# Central Planning Authority

**Minutes** for a meeting of the Central Planning Authority held on December 15, 2010 at 1:00 p.m. in the Conference Room, 1<sup>st</sup> Floor, Regatta Office Park – Leeward One.

**CPA/29/10**

**SET BACK FROM THE REAR BOUNDARY OR HIGH  
WATER MARK WHICH SHOULD BE 20 FEET**  
**Regulation 9 (8) (i)**

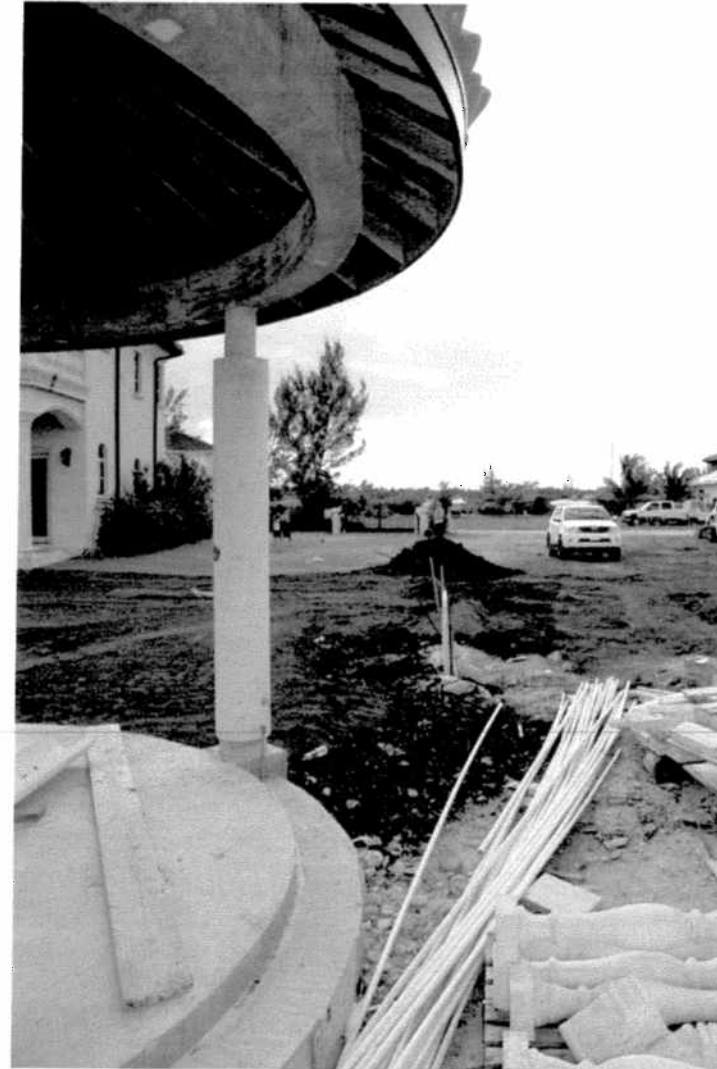
As you will note from the photograph the Gazebo's foundation slab is approx. 2 feet from the north sound sea wall. The roof is clearly less than 2 feet from the sea wall.

Also note that this is a recent photograph showing that the fascia has been completed since the Stop Work Notice was issued.

## A PHOTOGRAPH TAKEN AT THE TIME THE STOP NOTICE WAS ISSUED

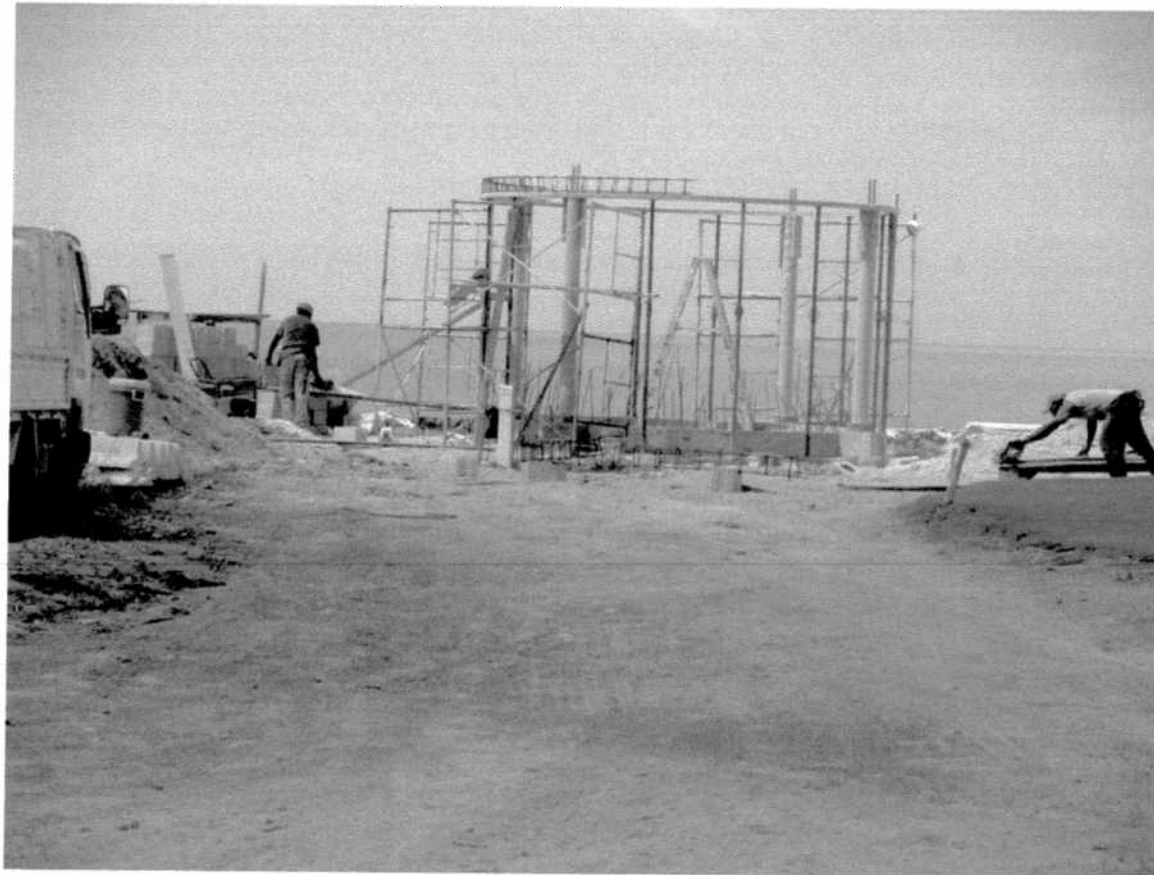
Please note that the Gazebo is clearly not situated 8 feet from our property boundary as it is indicated it should be in the Empire Development drawings submitted by Mr Lewis M Ebanks. We have not submitted a surveyor's report to evidence this for three reasons (1) Even if the structure was situated 8 feet away it is still in contravention of Regulation 9 (8) (j). (2) From the pictures it is clear that the structure significantly closer than the required 10 feet or even 8 feet. (3) We do not feel that we should pay the costs of such a survey.

The below photograph was taken on 7 September 2010 and the stop notice was issued on 8 September 2010. As you will note from the other pictures in this presentation the applicant Mr Lewis M Ebanks made a conscious decision to ignore the stop notice and continued to construct the gazebo.
